SAVE DOUGH MOUNTAIN

**Submission to An Coimisiún Pleanála
Proposed Lissinagroagh Wind Farm**

FuturEnergy Lissinagroagh DAC

Case References: ACP-323048-25 / PAX12.324290

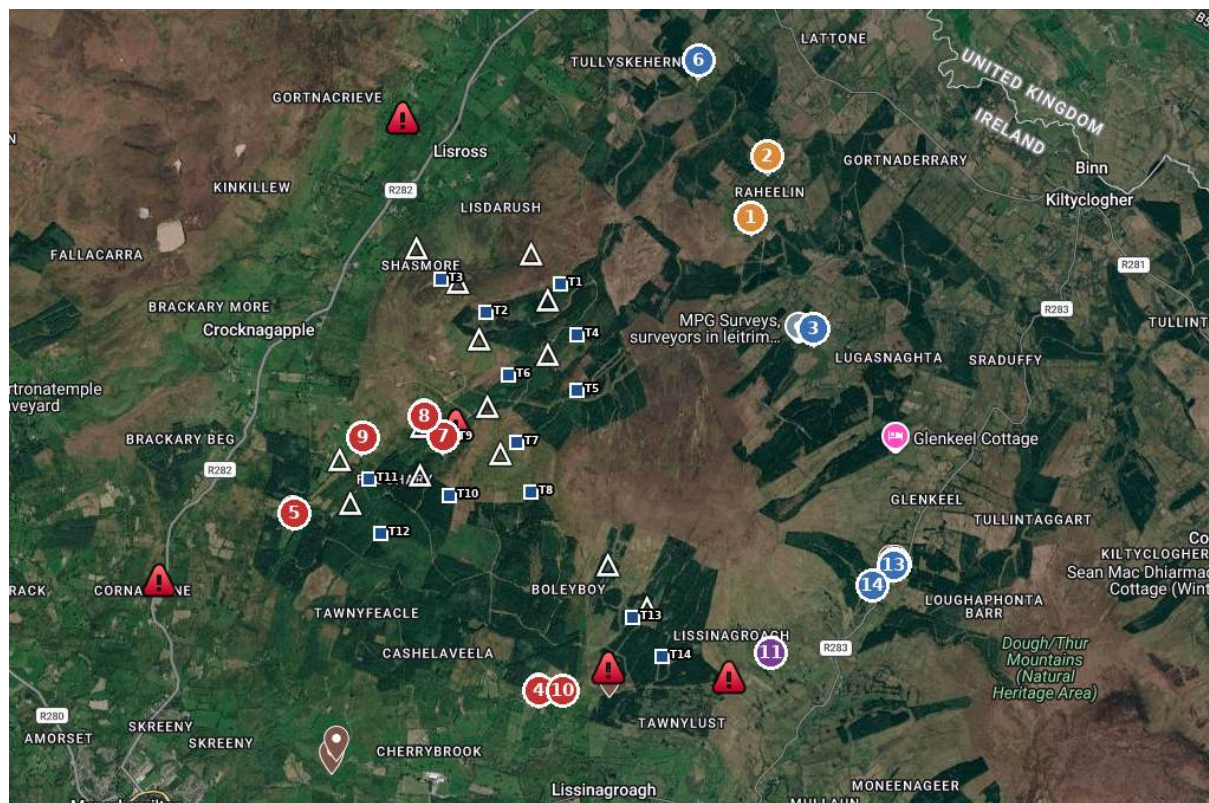
On the local survey, fourteen dwellings on the northern and eastern approaches to the array were recorded and photographed on the ground by Save Dough Mountain and are shown, against the proposed turbine layout, on the receptor map at Figure B.3. Of these, five are occupied, two are vacant, and the remainder are recorded as derelict. None appears on the applicant's Appendix 4-1 receptor schedule, and none is represented by a Chapter 13 viewpoint. The occupied dwellings lie on the side of the site where the applicant's own local community viewpoints, VP14 and VP15, are used to demonstrate southward screening that these dwellings do not share; the nearest occupied dwelling lies on the order of 2.1 km from the closest turbine. The vacant and derelict dwellings are more striking still: several sit among the turbines themselves, the closest recorded as derelict at approximately 66 m, 323 m and 386 m from Turbines 9 and 11. The significance of the occupied omissions is argued in Sections 3, 8 and 14; the significance of the vacant and derelict dwellings, on a receptor baseline that discounts present vacancy, is argued in Sections 9 and 14. It is set out here as a receptor-completeness matter.
